**PLEASANT PRAIRIE PLAN COMMISSION MEETING
VILLAGE HALL AUDITORIUM
9915 39th AVENUE
PLEASANT PRAIRIE, WISCONSIN
6:00 P.M.
April 8, 2019
AGENDA**

**PLEASANT PRAIRIE PLAN COMMISSION MEETING
VILLAGE HALL AUDITORIUM
9915 39TH AVENUE
PLEASANT PRAIRIE, WISCONSIN
6:00 P.M.
March 11, 2019**

Attachment: Plan Mark Up
VOPP water main extension reference maps

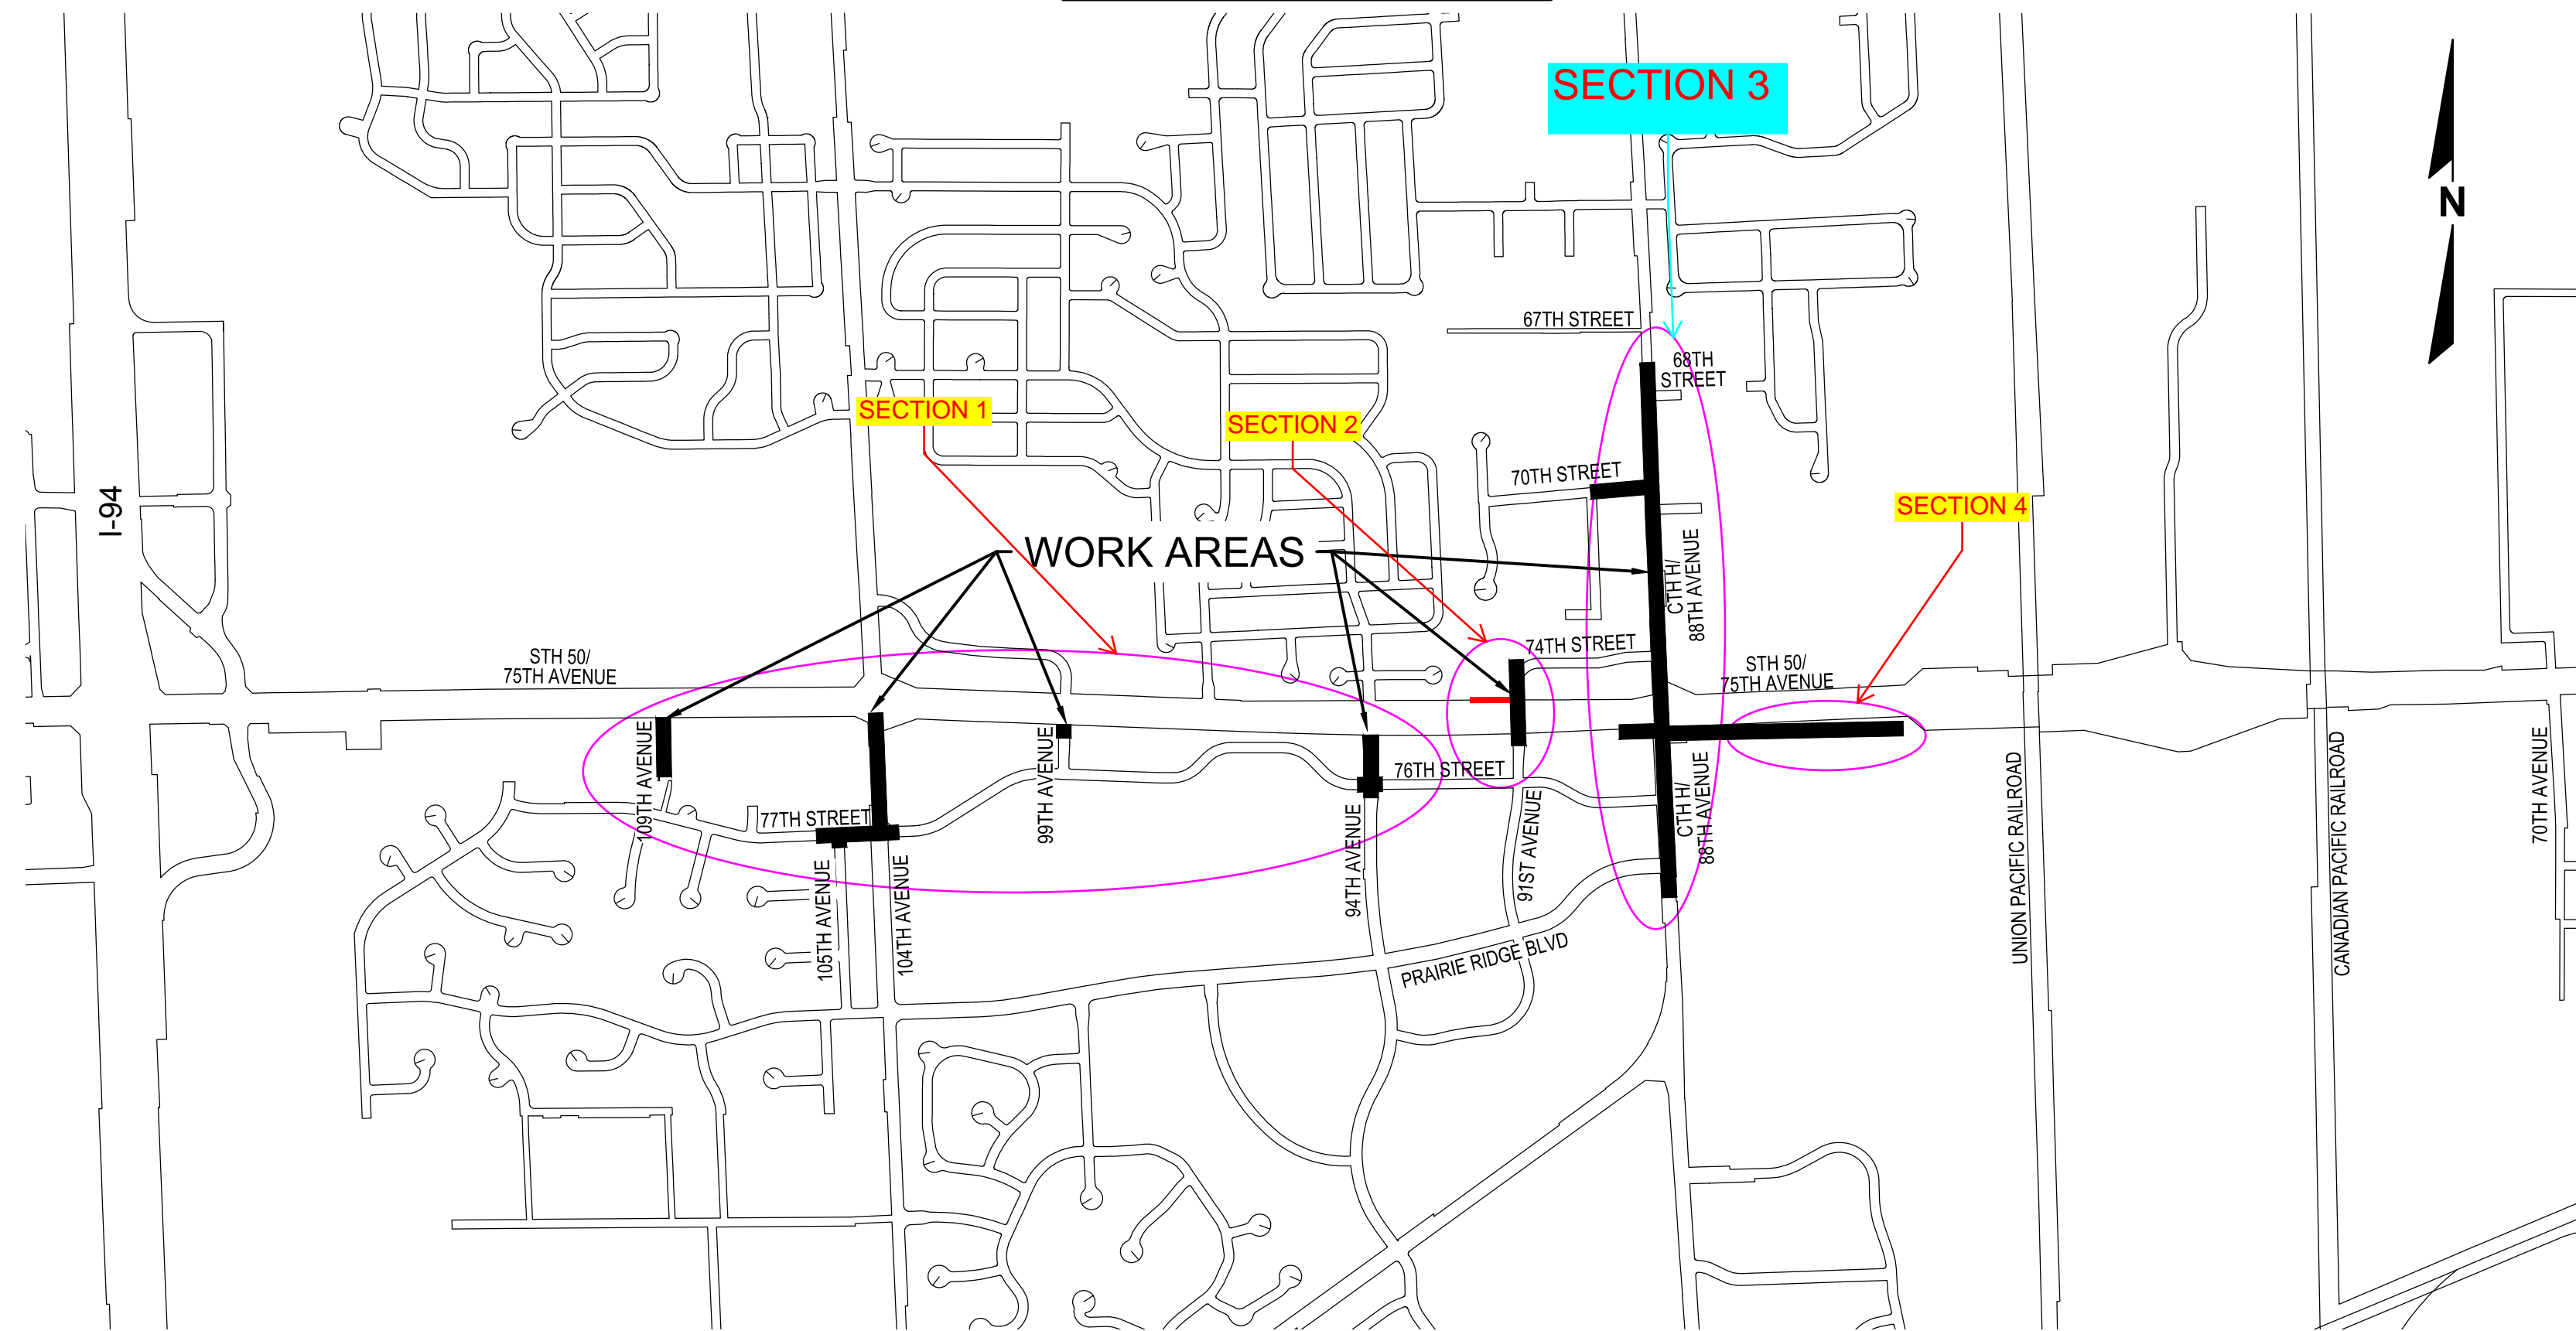
The engineering plans have been reviewed for conformance with generally accepted engineering practices and Village policies. Although the data has been reviewed, the design engineer is responsible for the thoroughness and accuracy of plans and supplemental data and for their compliance with all state and local codes, ordinances, and procedures. Modifications to the plans, etc. may be required should errors or changed conditions be found at a future date and as additional information is provided.

104th STREET - LAKEVIEW PARKWAY S.T.H. "165" (VARIABLE R.O.W.)

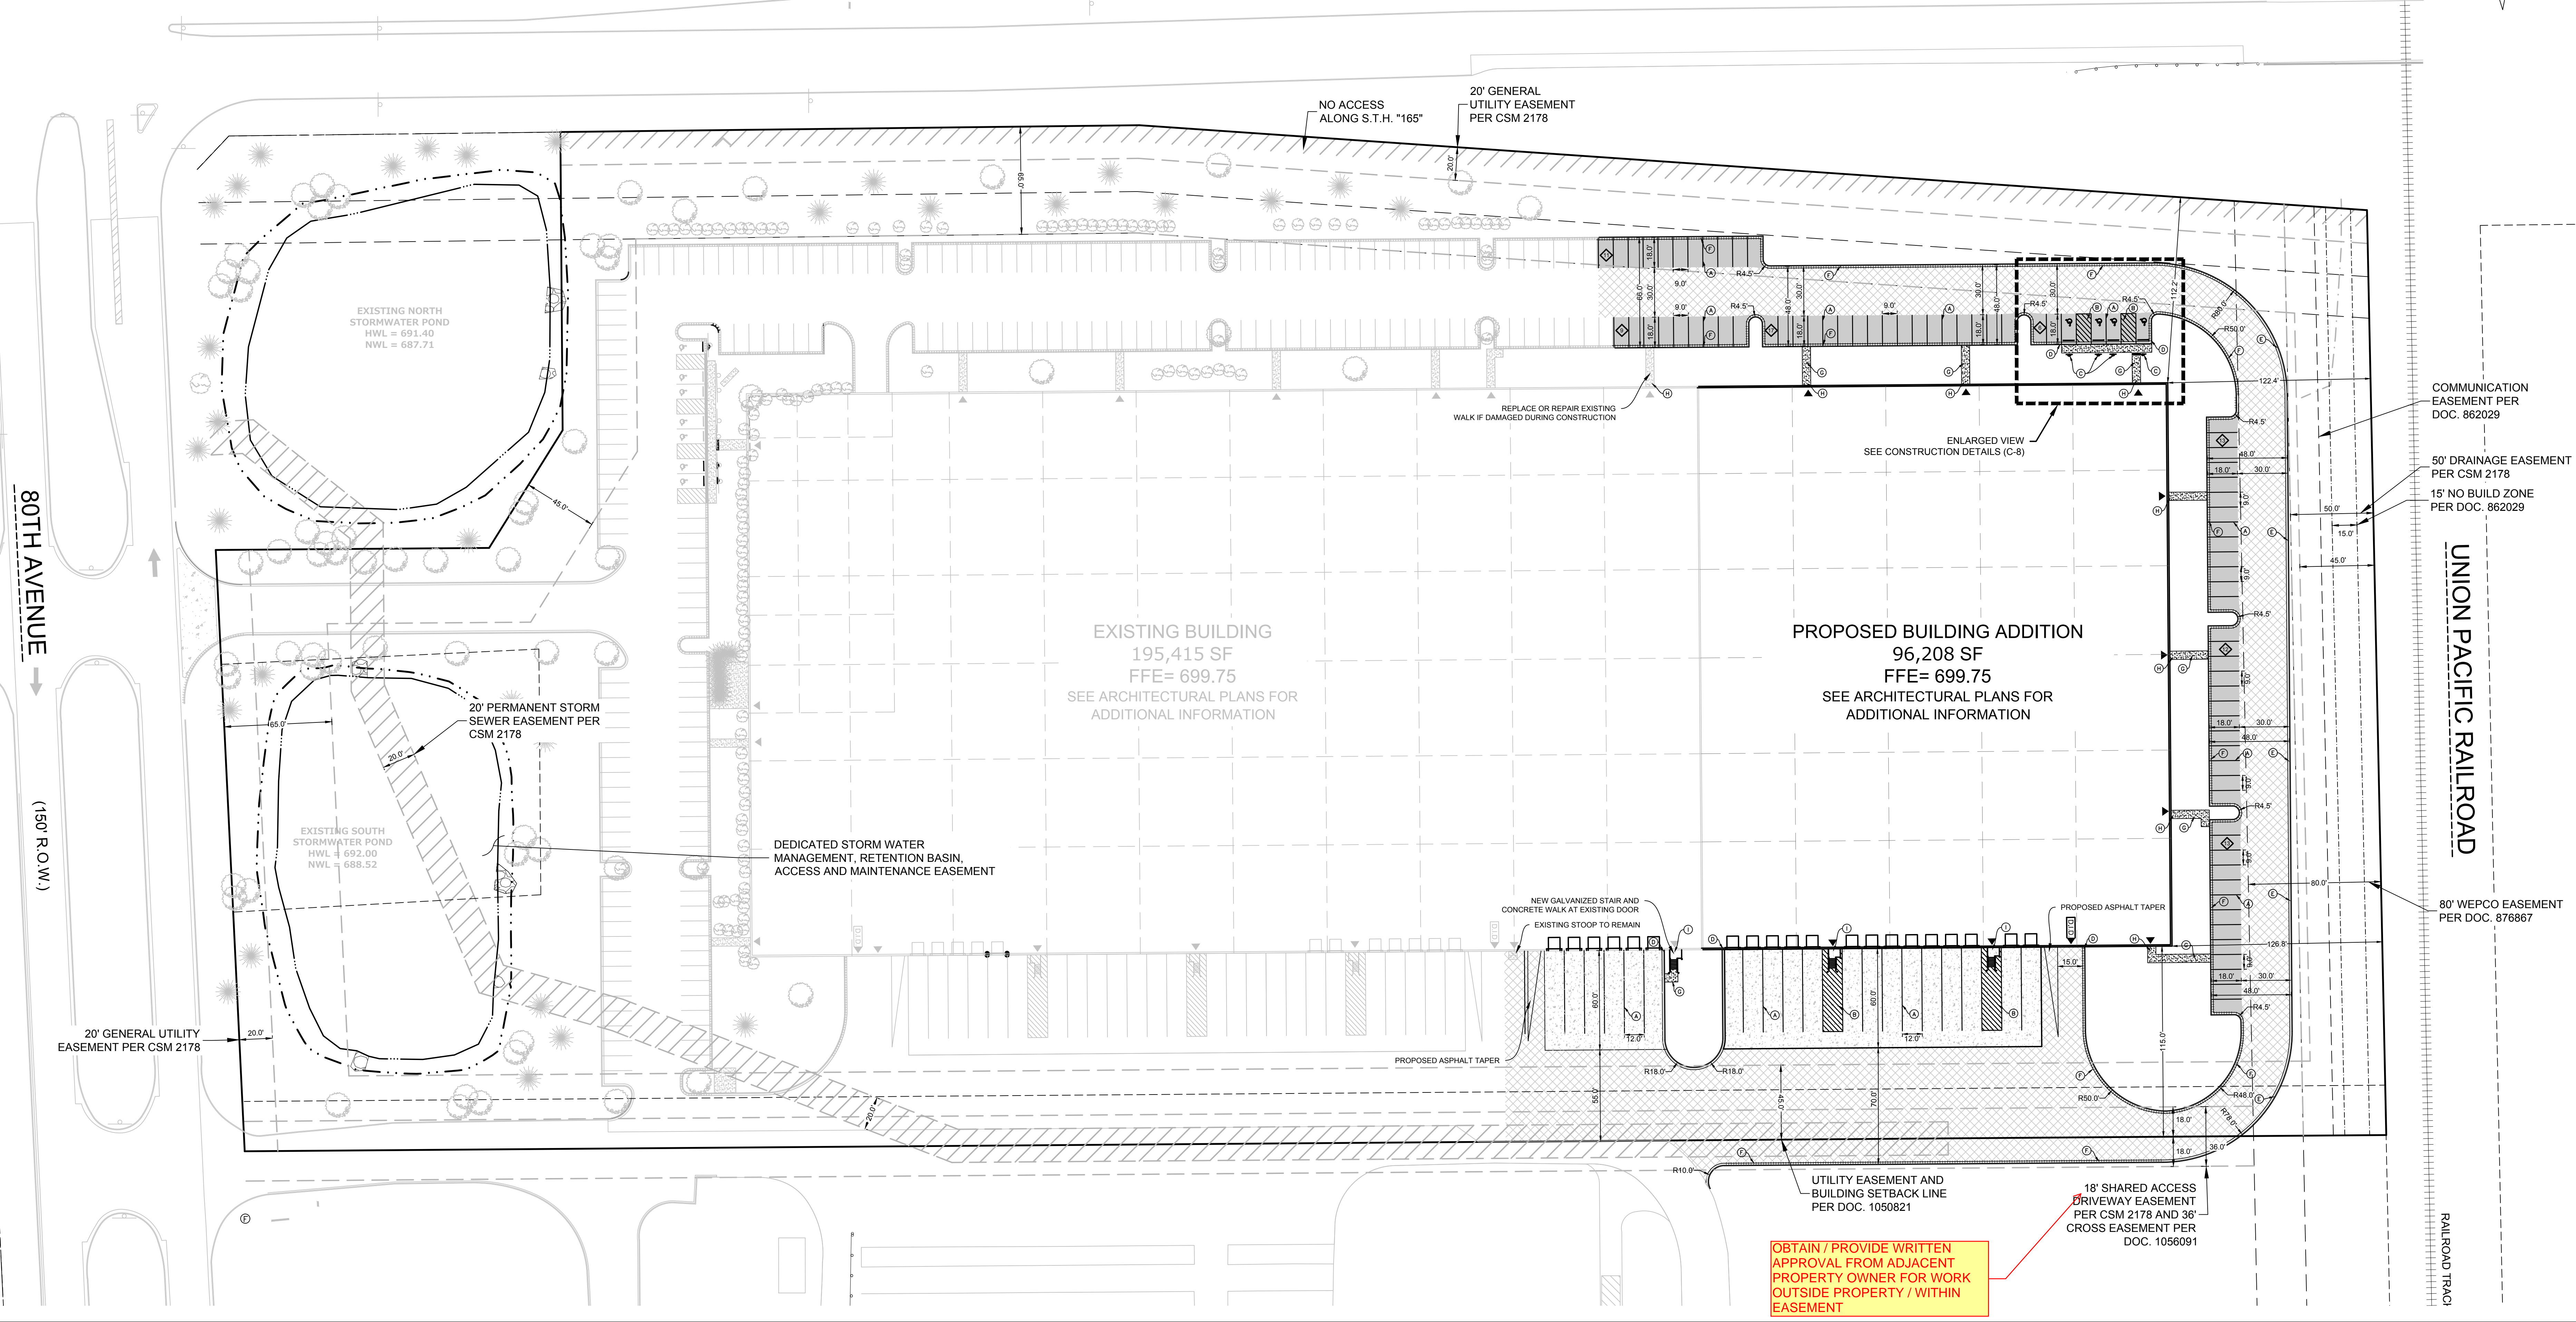
- n. On the Cover Sheet, update the location map to represent *State HWY 31* and remove the presumed building by 72nd.
 - o. On Sheet C-3, note what each dashed lines are adjacent to STH 165. Any work in an easement will require approval from the easement holder.

OBTAIN / PROVIDE WRITTEN APPROVAL FROM ADJACENT PROPERTY OWNER FOR WORK OUTSIDE PROPERTY / WITHIN EASEMENT
